Petition Number: #2022-105

From: Jake Carpenter, PE

<b>Revision Log:</b>	Date	Description	
	11-28-22	First Review (PM)	
	12-22-22	Second Review (DR)	
	2-22-23	Third Review (JP)	
	12-19-23	Fourth Review (IW)	
	04-09-24	Fifth Review (IW)	
04-22-24		Sixth Review (IW)

#### Transportation Summary

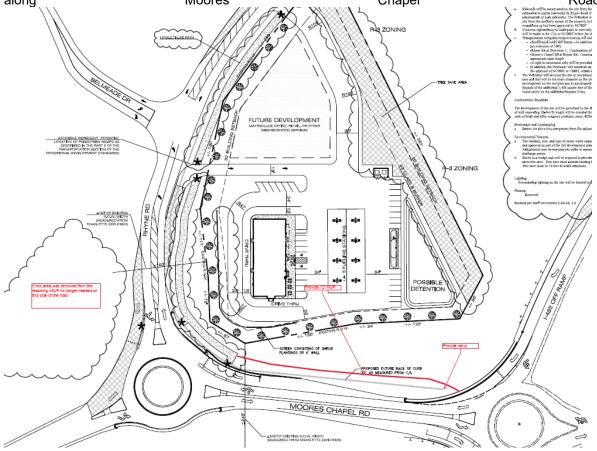
- 3. New Comment from 04/09/2024: Remove improvement below. This has already been constructed. Only improvement at Rhyne Road and Belmeade Road intersection should be what is circled below.

Remove

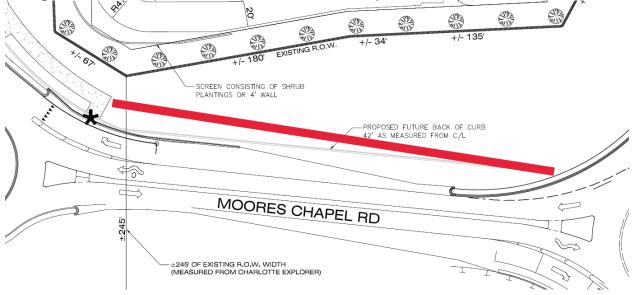
**Clarifying Comment from 12/22/2022:** Label and dimension streetscape along all public road frontages (12-foot multi-use path and 8-foot planting strip). Revise ramp locations as shown above and update conditional note to incorporate additional ramps. Provide SUE located 2-feet behind sidewalk if located outside of the ROW. Add conditional note to coordinate Control of Access Break with NCDOT for proposed multi-use path along Moores Chapel Road.

**Clarifying Comment from 4/24/2024:** Sidewalk facilities are required per City ordinance for all public road frontages, including Moores Chapel Road. It is understood that the previous tree save parcel is no longer included in the petition and improvements are not required for that parcel.

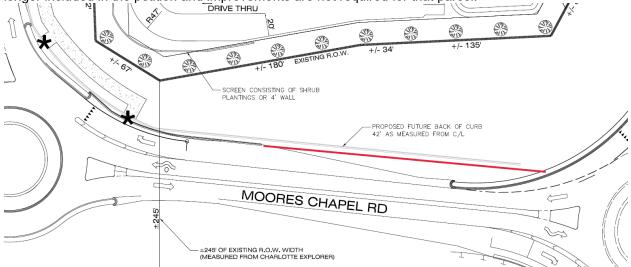
5. **Outstanding Comment** Revise site plan and conditional notes to provide curb and gutter along the public roads that front the proposed tree save parcel. The minimum distance to the back of curb and gutter is 19-feet from the centerline of Rhyne Road and 30-feet from the centerline of Moores Chapel Road.

**Clarifying Comment from 2/22/2023:** If the tree save area to the west of Rhyne Road was removed from the rezoning, MUP will no longer be required on the west side of Rhyne Road – clarify whether parcel west of Rhyne Road is included in the petition. The MUP along Moores Chapel is required for the rezoning petition. If NCDOT does not allow the MUP during site plan permitting, it will not be required to be constructed. Curb and gutter required for all public street frontages – label, dimension, and commit to curb and gutter and MUP in conditional notes.

**Clarifying Comment from 4/24/2024:** Curb and gutter is required per City ordinance for all public road frontages, including Moores Chapel Road. It is understood that the previous tree save parcel is no longer included in the petition and improvements are not required for that parcel.
